MITSUBISHI HEAVY INDUSTRIES, LTD.
16-5, KONAN 2-CHOME, MINATO-KU
TOKYO, JAPAN

Docket No. 52-021
MHI Ref: UAP-HF-11244

Subject: MHI's Responses to US-APWR DCD RAI for Chapter 7, Response to the Additional Questions from the NRC, Revision 8 of the Technical Report MUAP-07005-P "Safety System Digital Platform –MELTAC-", and mark up of DCD Tier 1 on Revision 3

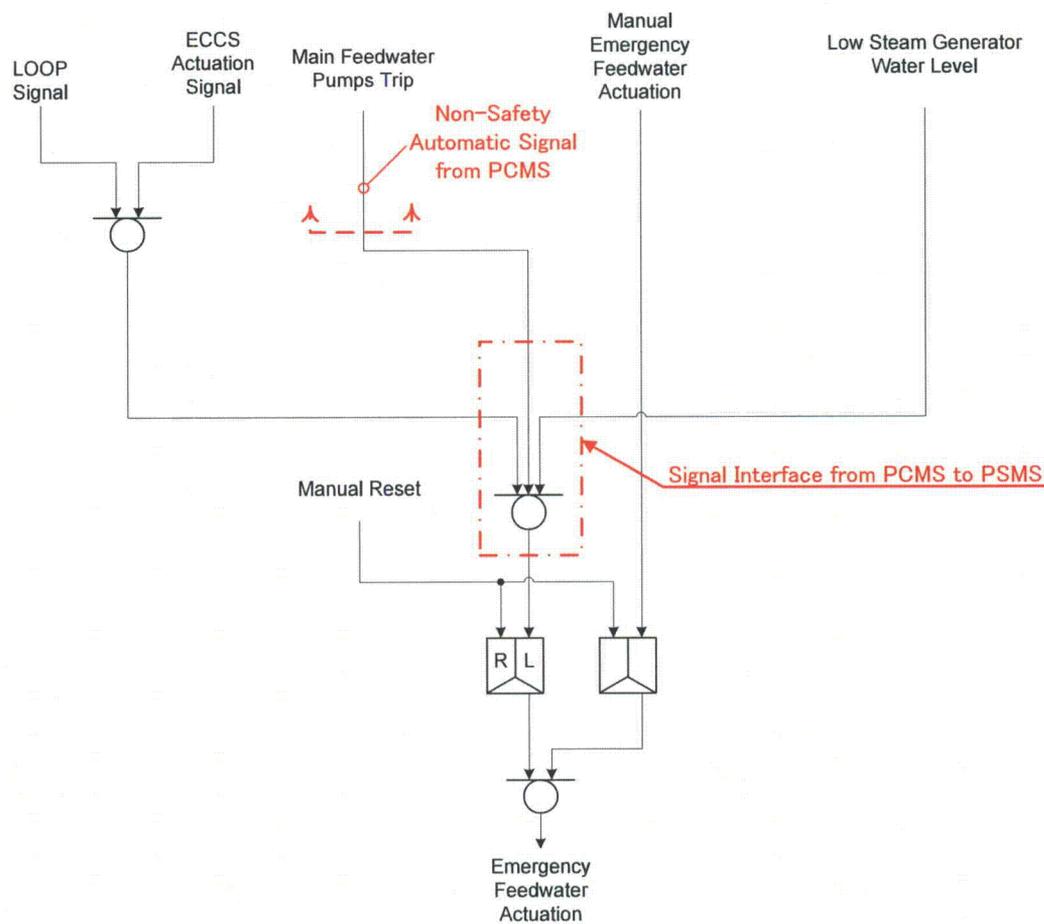
The non-safety automatic control signals of the safety-related functions from the PCMS enhance the plant safety as described in Subsection 7.7.1.13 of the DCD markup submitted to the NRC on May 31st (MHI Letter No.UAP-HF-11159).

The interface logics for the non-safety automatic control signals from the PCMS consist of simple "AND" and "OR" logic functions within the PSMS, as shown typically in Figures 1 (a) and (b), below. Therefore, the added complexity for these additional signals and logic functions in the PSMS is very limited. In all cases, safety-related signals in the PSMS have priority over these non-safety automatic control signals from the PCMS.

If the non-safety automatic control signals from the PCMS to the PSMS are interfaced by hardwired cables, the "AND" and "OR" logic functions shown in Figures 1 (a) and (b) are still needed in the PSMS. In addition, for the hardwired cables interface design must require additional hardware devices in the PSMS, such as, binary I/O modules, isolation modules, etc.

Figure 2.5.6-1 DCS Configuration

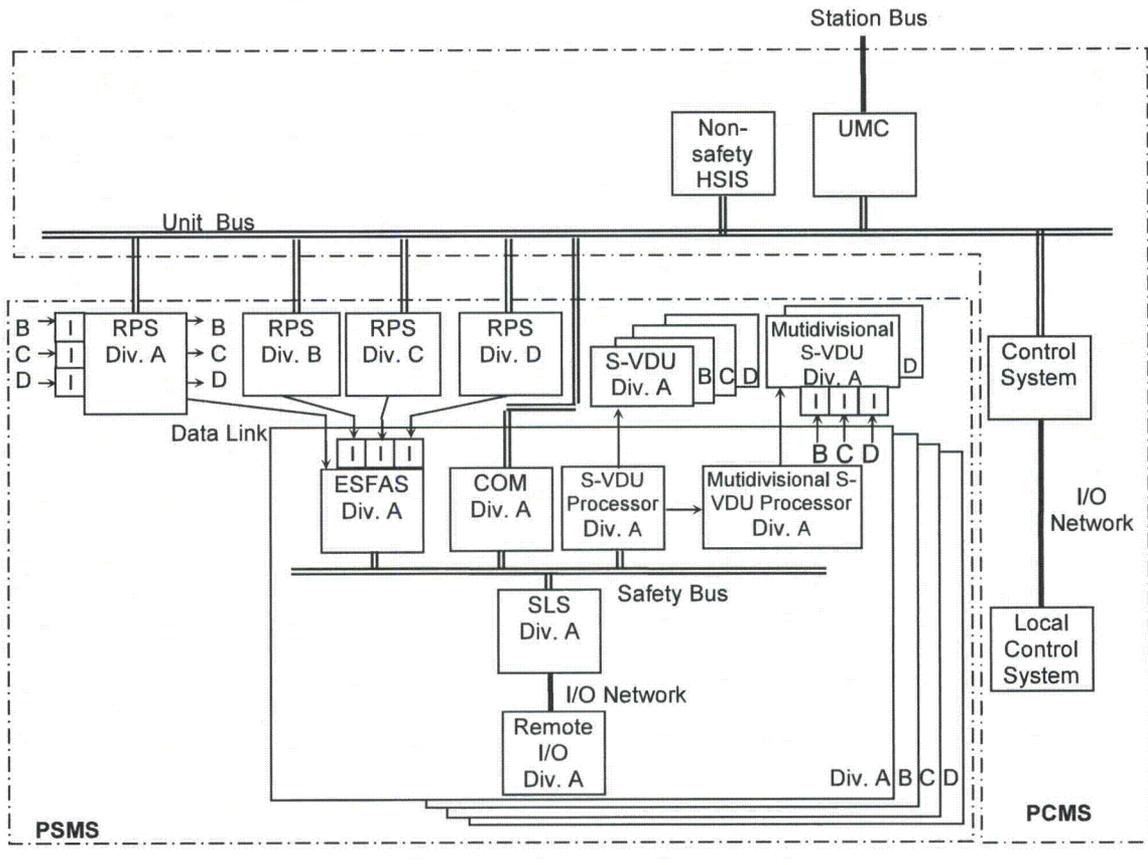
No.	Additional Questions from the NRC	Response to the Questions from MHI	Documents to be Revised
1	Clarify the number of multidivisional safety VDUs and make appropriate changes of the Safety I&C Technical Report.	Subsection 4.2.4 will be revised to clarify the number of multidivisional VDU as shown in markup of Safety I&C Technical Report.	Safety I&C Technical Report (MUAP-07004) See Attachment-4
2	Should Figure 2.5.6-1 of DCD Tier 1 Markup be revised (1) change division to train and (2) to include the proposed multidivisional safety VDUs?	Figure 2.5.6-1 of DCD Tier 1 will be revised to incorporate the multidivisional VDU.	DCD Tier 1 Figure 2.5.6-1 See Attachment-3
3	Section 7.7.1.13 of DCD Rev. 4 Markup (page 7.7-19) states "The reasons why the unit bust interface is selected are described in Subsection 7.9.1.2" regarding non-safety automatic control signals interface from PCMS to PSMS via the unit bus. Subsection 7.9.1.1.2 should be referred instead.	Subsection 7.7.1.13 will be revised to correctly refer Subsection 7.9.1.1.2 as shown in markup of DCD Chapter 7 (Attachment-2).	DCD Tier 2 Subsection 7.7.1.13 See Attachment-2 (yellow highlighted)
